### BULLETIN INFORMATION

Following a recent failure of a GSM-R Cab Radio in operational service and the issue of NIR 2876, an investigation is being carried out to check and rectify where necessary the fixing arrangements for the GSM-R Handset base.

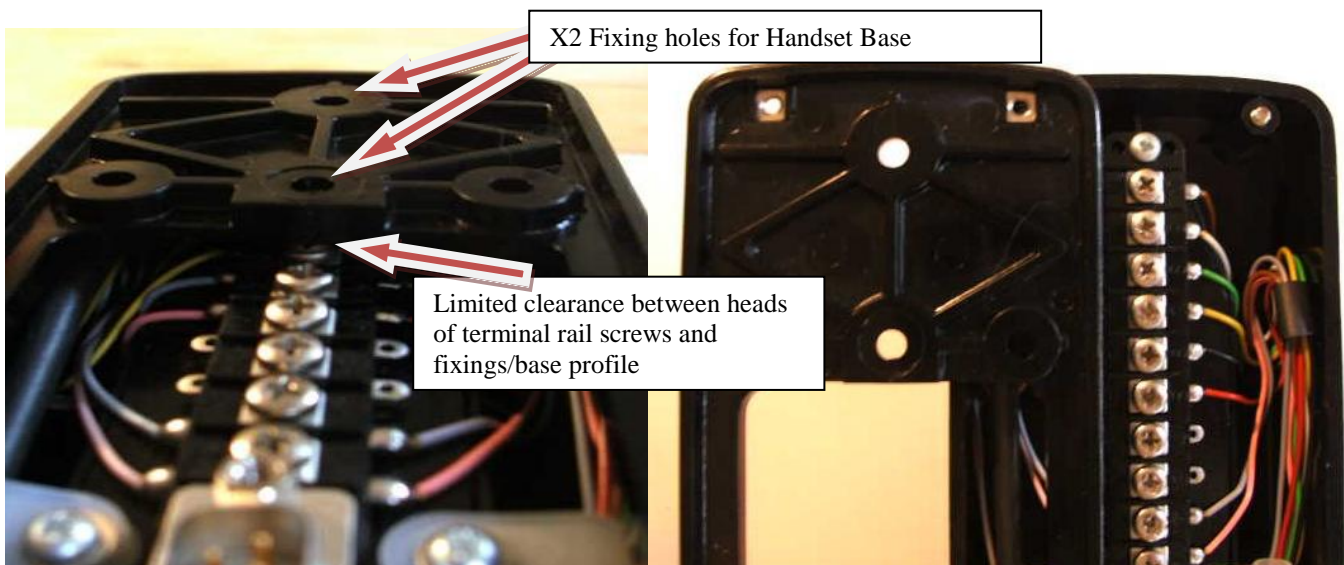
The symptom of the failure was a loss of voice from the Driver's GSM-R Handset microphone when calling the signaller. The initial investigation on a South West Trains c159 GSM-R installation identified that the fixing arrangement of the Handset Base was as per design, however, it provided a short circuit between the microphone +ve terminal T10 mounted on the Handset Cradle to the vehicle earth via the fixing itself and the metal Handset housing.

A Project review of other GSM-R installation designs has identified that a number of designs specify either the use of M4 spring washers or M4 Form A plain washers under the M4 Pan Head screw which then raises the profile of the fixing above the recess depth and could provide a similar failure mechanism. This does not align with the Siemens Interface Control Document 666/UJ/86001/000 iss 5 which states *"The fixing screws should be Pan Head type and should NOT have a washer fitted under the head."*

The ICD also details that the handset being mounted using qty x4 M5 fixing screws, however, the apertures in the base moulding will not accommodate for M5 fixings. This has been confirmed by Siemens as an error and that M4 fixings should be used.

If only the top fixing is used then the short circuit can appear between the brown wire at terminal T10 (pin 2 on D-type) and vehicle earth.

If the second down fixing is used then the short circuit can appear between terminals T6 (pin 10 on D-type), T7 (pin 4 on D-type) and vehicle earth.

The Project have contracted Interfleet Technology Ltd to carry out an independent design review. This has been completed and a report produced (ref T28659/305 20130104-LET-NR attached) that recommends the use of M4 Pan Head screws, with no washers under the screw head and Loctite 222 applied to the screw threads on installations that use rivnuts/threaded inserts.

The action to resolve this issue is to carry out a fleet wide check on GSM-R Handset installations that have been identified as incorporating a washer under the screw head and remove the washer, apply Loctite 222 Threadlocker to the screw thread and refit and undertake a handset test (On DCP press menu button MU, option 5 - Maintenance Menu and then option 2 - Handset Test).
